CITY OF ALAMO HEIGHTS
COMMUNITY DEVELOPMENT SERVICES DEPARTMENT
6116 BROADWAY
SAN ANTONIO, TX 78209
210-826-0516

Architectural Review Board Meeting
April 22, 2025 – 5:30 P.M.

Case No. 982F – 271 Retama Pl

Request of Myles Caudill of Caudill Homes, applicant, representing La Pila Ventures, owner, for the compatibility review of the proposed design located at 271 Retama Place in order to construct a new single-family residence with detached garage under Demolition Review Ordinance No. 1860 (April 12, 2010).

SITE PLAN
1/8" = 1'-0"

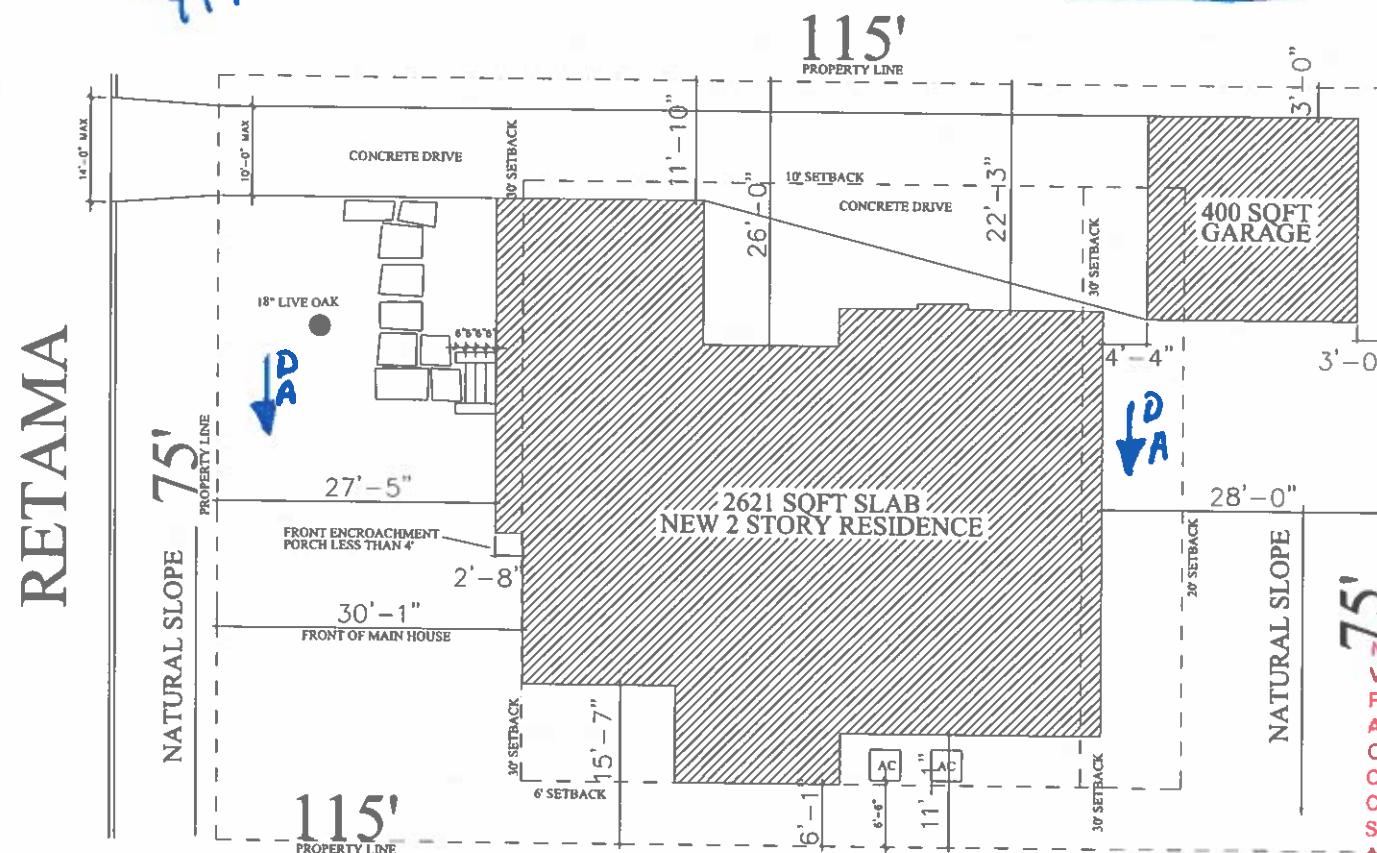
SUBJECT TO FIELD INSPECTION

FOUNDATION FORM BOARD SURVEY REQUIRED PRIOR TO FOUNDATION INSPECTION

NOTE: FAILURE TO DISCOVER ALL CODE VIOLATIONS THROUGH THE CITY'S PLAN REVIEW PROCESS DOES NOT RELIEVE THE DESIGNER AND CONTRACTOR FROM THE RESPONSIBILITY OF PRODUCING AN END PRODUCT IN TOTAL COMPLIANCE WITH ALL REQUIREMENTS OF THE CURRENTLY ADOPTED INTERNATIONAL CODE SERIES AND THE CODE OF ORDINANCES OF THE AUTHORITY HAVING JURISDICTION.

*Shall comply w/
Drainage requirements.
*Tree removals require
separate permit.

SOUTH ELEVATION
1/4" = 1'-0"

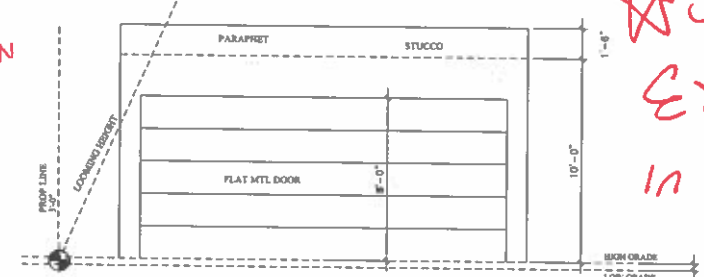
Shall not
Exceed 14'
in Height
